**Article No.
00-4-2**

**VIBRATION/SHAKE—AT STEADY SPEED
APPROXIMATELY 100 KM/H (62 MPH)—VEHICLES
WITH 3.8L ENGINE AND CONVERTIBLE TOP**

FORD: 1996-1998 MUSTANG

Figure 1 - Article 00-4-2

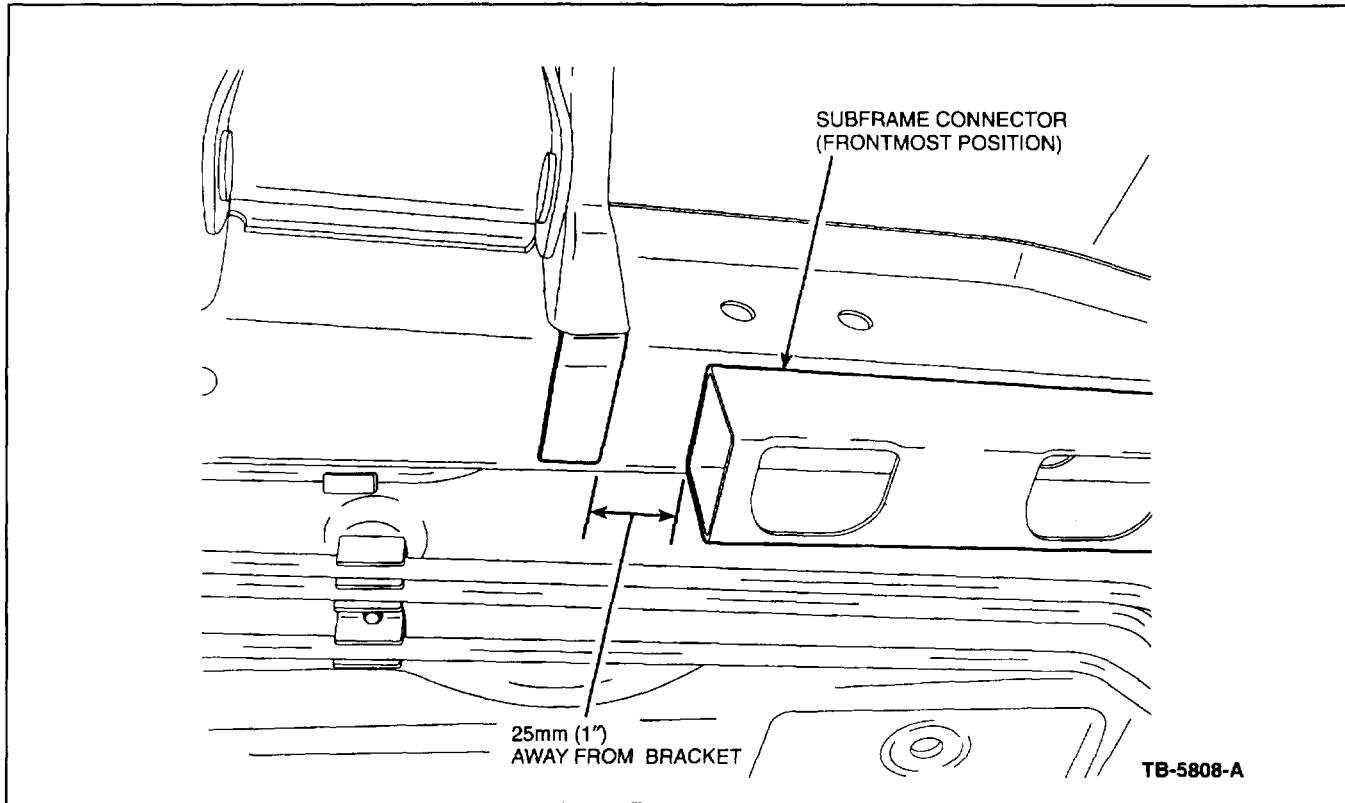
11. Install a set of Underbody Rails (XR3Z-76101W09-AA - Left and XR3Z-76101W08-AA - Right). Refer to Figure 1 to determine where to place the rails to the underbody. The underbody rails will need to be welded to the underbody of the vehicle, referring to the following:

Figure 2 - Article 00-4-2

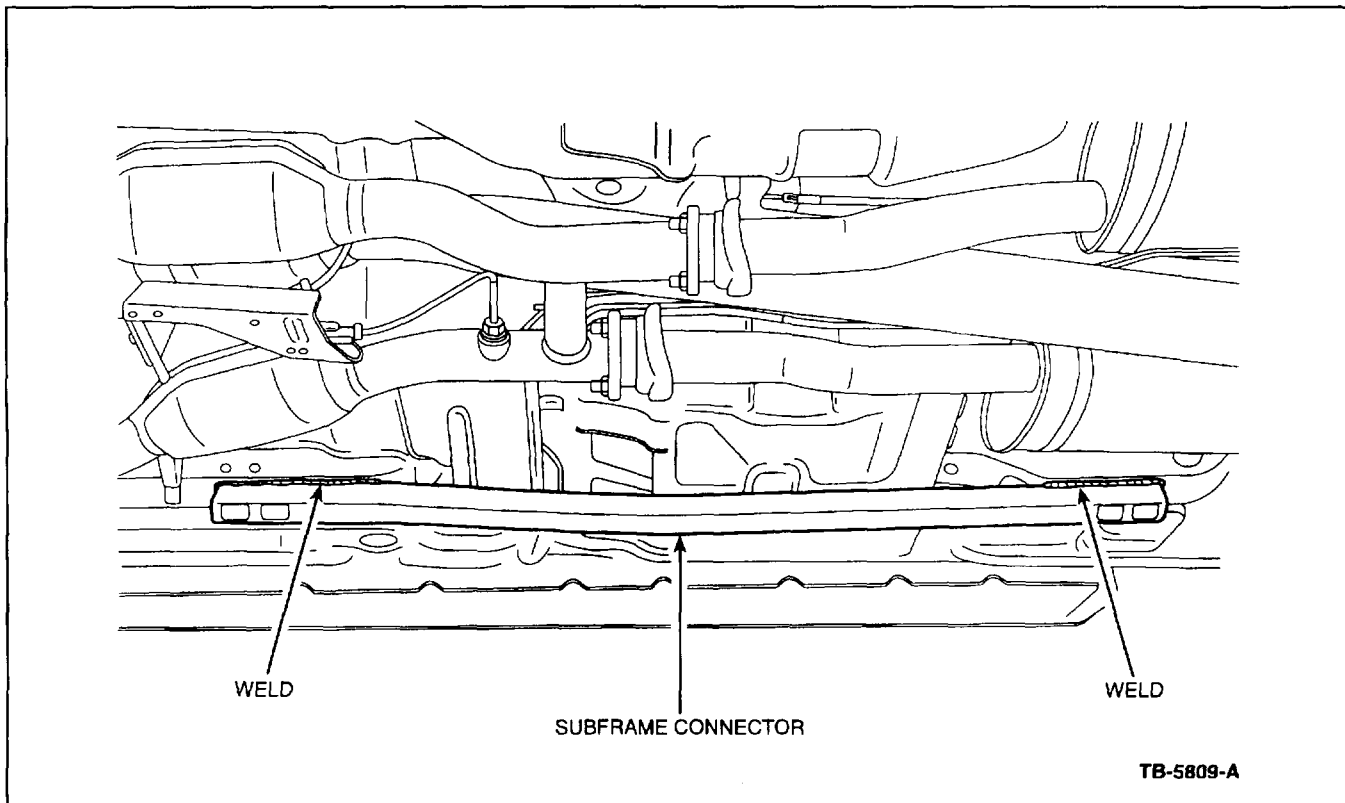
- The welds should have a minimum 5mm (0.25") weld bead and a minimum total length of 75mm (3") on both sides of the rail (Figure 2).
 - Upon completion, the welded area should be treated for corrosion using Super Seal Anti-Corrosion Compound (F3AZ-19515-SA or equivalent meeting Ford specification ESR-M7C54-A).
